Pre-Paint & Waterproofing Report.

Inspection Date: 28 Feb 2020

Property Address: Rockbank Area

2.01

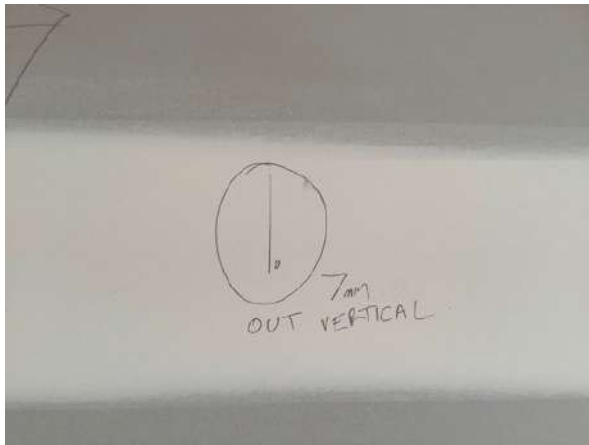
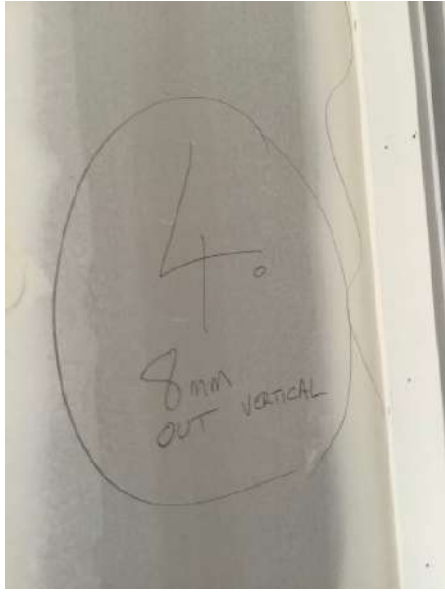
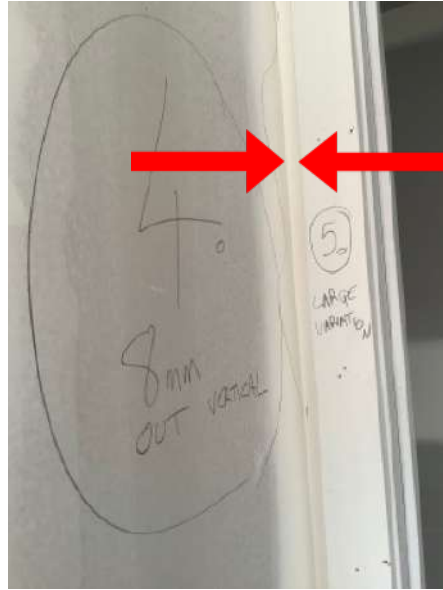
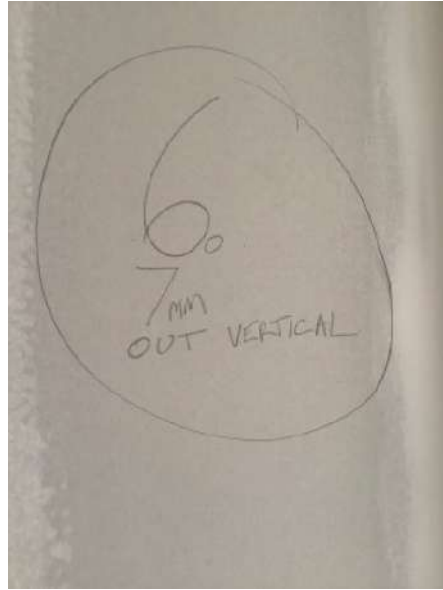
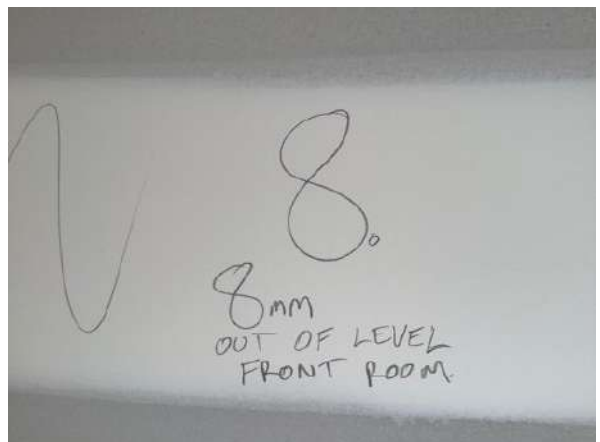
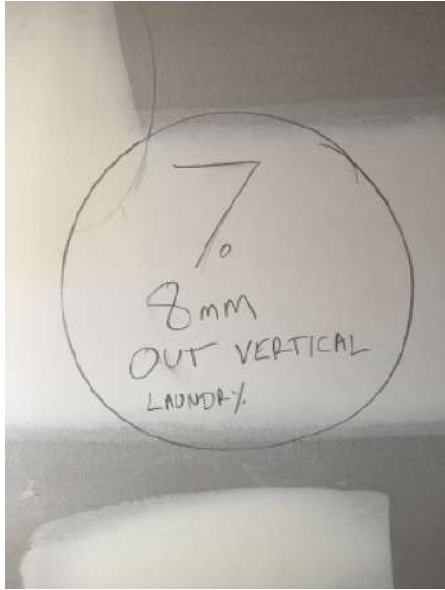
Finding: Various Plaster Walls / Frame / Posts - Not Square Or Vertical Or Horizontal (Maximum Variation Is 4mm Over 2 mtrs)
 Procedure for checking the walls, cornices and timber fixing was performed.
 A deviation (large bow) exceeding 4mm measured across a 2 mtr straight edge was identified in all the areas as per the photos attached & any gaps larger then 4mm is considered a defect and requires considerable re-working of the plaster and possible timber framing in all the areas to rectify the defects.

It is observed that plaster walls / frames are defective as there is a deviation from a vertical or straight plumb line in any direction which exceeds 4mm within any 2m of height / length. This is a technical defect and may result in subsequent structural defects if left unmanaged.

This is commonly referred to as a bow in the frame material and/or defective workmanship. Any bow in excess of 4mm as identified exceeds the allowable Standards and Tolerances and is considered defective.

Frames are defective if they deviate from plane (horizontal or vertical bow) by more than 4 mm in any 2 m length of wall.

This deviation from the verticality / horizontal or plumbness of the wall is a defect with reference to Standards and Tolerances 9.10.

-/ We refer the builder to AS 2589, clause 4.2.2.

A registered builder should be appointed to assess the defect and perform rectification works as necessary.
